## COR2528 - Smart Metering / DCC Day 1

### Gas Smart Working Issues Group (SWIG), Consequential Changes Report (v1.0) - Potential Solutions

Figure 1: RGMA ORJOB Schematic with IHD Data Set optionally included

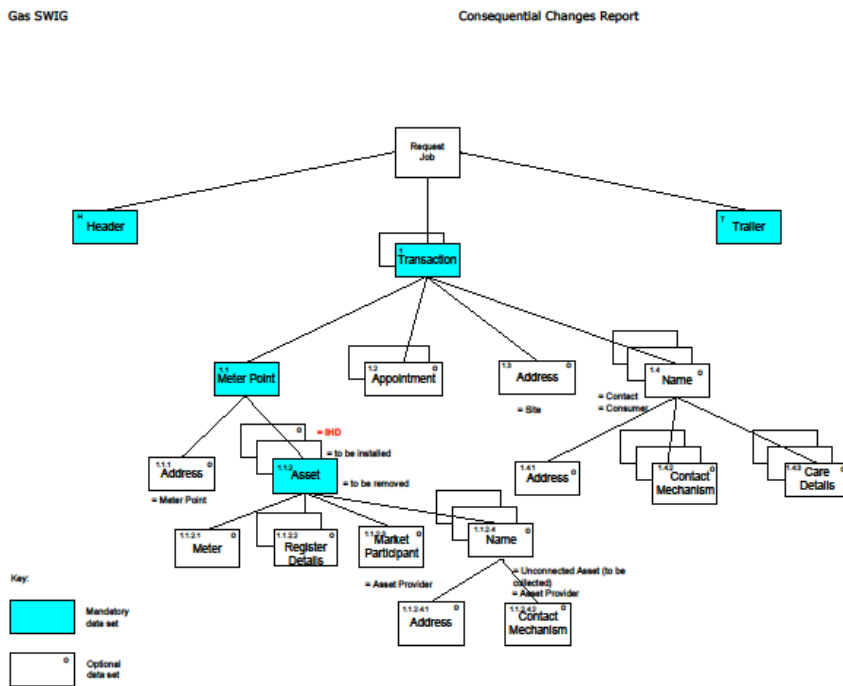
- 4.16** **Associated RGMA ORJOB Changes**  
 Optional Solution - The following schematic details the change, in red, for optional inclusion of a request to provide an IHD to non-domestic consumers in the RGMA ORJOB Request Job flow.
